DRB CASE ACTION LOG (SITE PLAN FOR BUILDING PERMIT)

DRB Application No.: 07DRB-70215 (SBP)
Project Name: L'IL SQUIRRELS PRESCHOOL
Agent: GARLAN BRYAN ARCHITECT

Site Plan for Building Permit

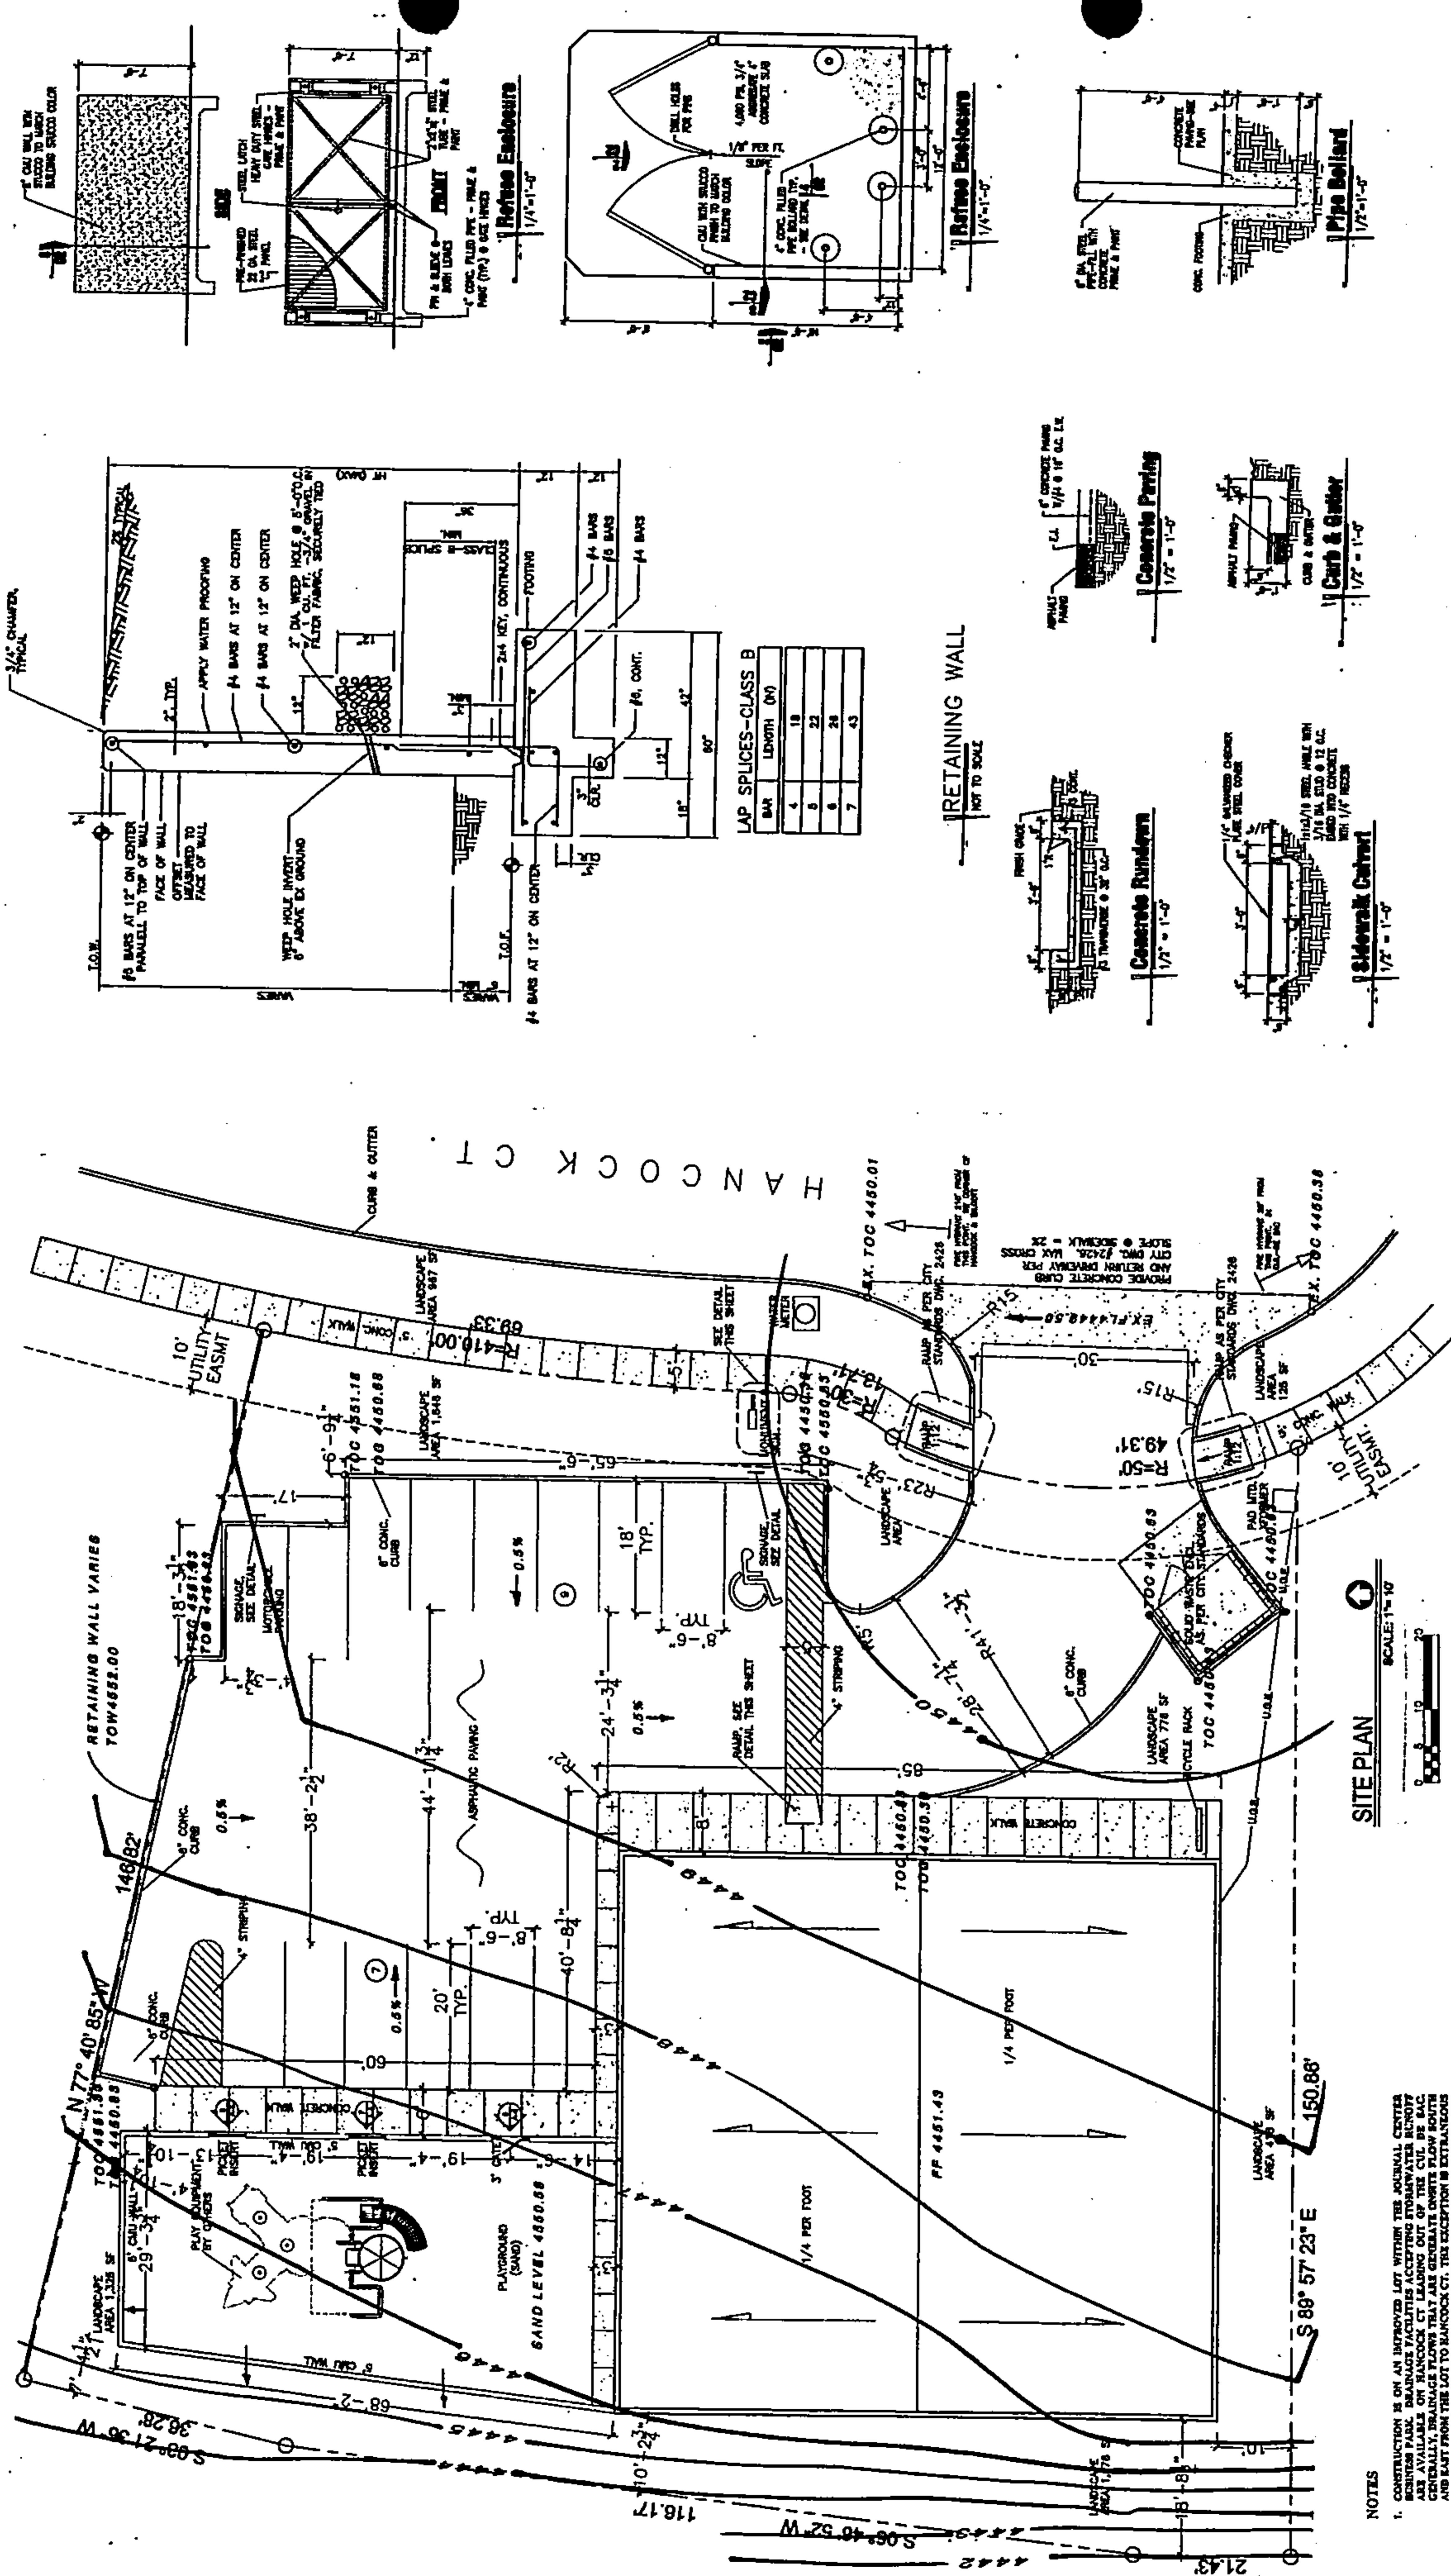
ADA space needs to be van accessible (8' aisle). Is the sidewalk existing? The ADA ramps also require truncated domes. The motorcycle stall should be 10' max. length and 4' in width. The parking stalls at the play area need bumpers or else provide 18' depth with an 8' sidewalk.

No objection to Site Plan approval other than show size of existing water tap and show existing sanitary sewer stub.

- 1. The SBBP Checklist lists the order of the pages of the site plan. In the future, be sure to follow that order.
- 2. The signature block is missing from the site plan sheet. The site plan sheet title should read "Site Development Plan for Building permit".

- 3. IP zoning allows one monument sign for each street frontage of at least 200 feet. See Section 14-16-2-19(A)(25) of the City Zone Code. According to the site plan submitted, this site does not meet this requirement.

- 4. The building total square footage and the use should appear on the building on the site plan sheet.
- 5. What type of outdoor lighting is planned?
- 6. The tree well detail (or planting detail) is a required element of the Landscape Plan.

LANDSCAPE PLAN
 SCALE: 1" = 10'

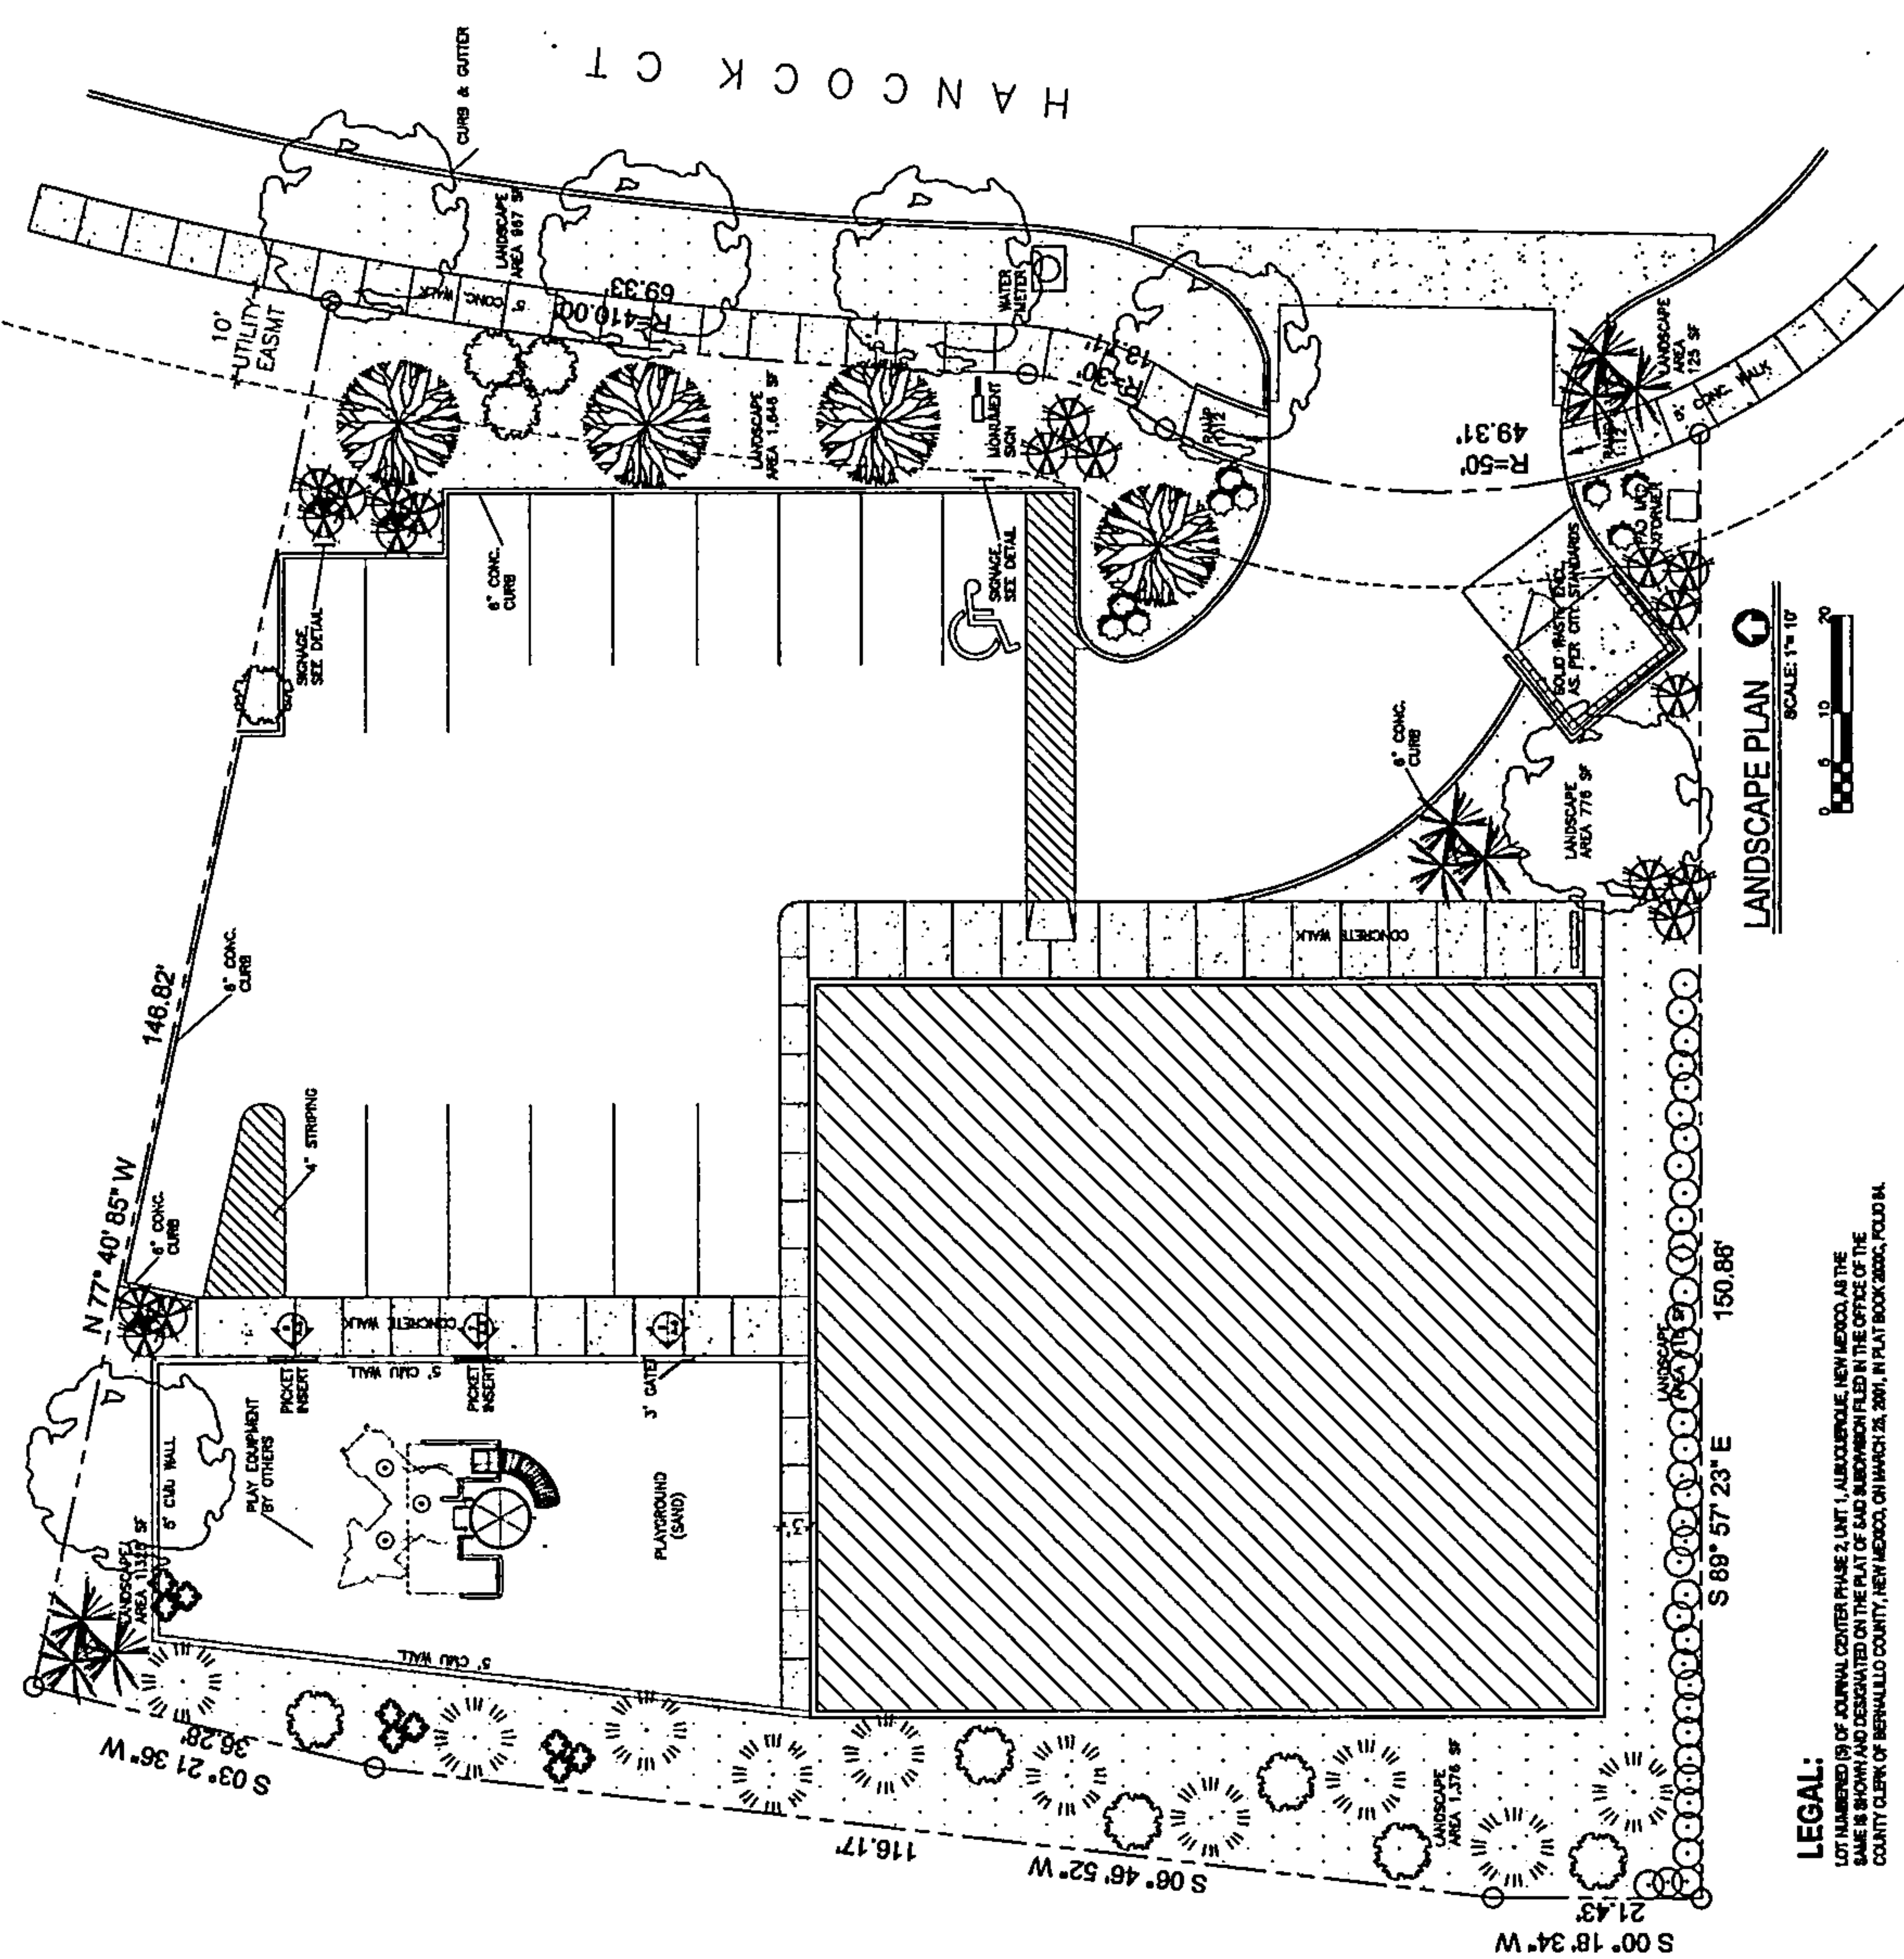
- 7. Santa Fe Brown gravel is required to a minimum depth of 3 inches. Indicate in the note on the Landscape Plan.
- 8. The building elevation sheet is very sparse in details, including specific colors.
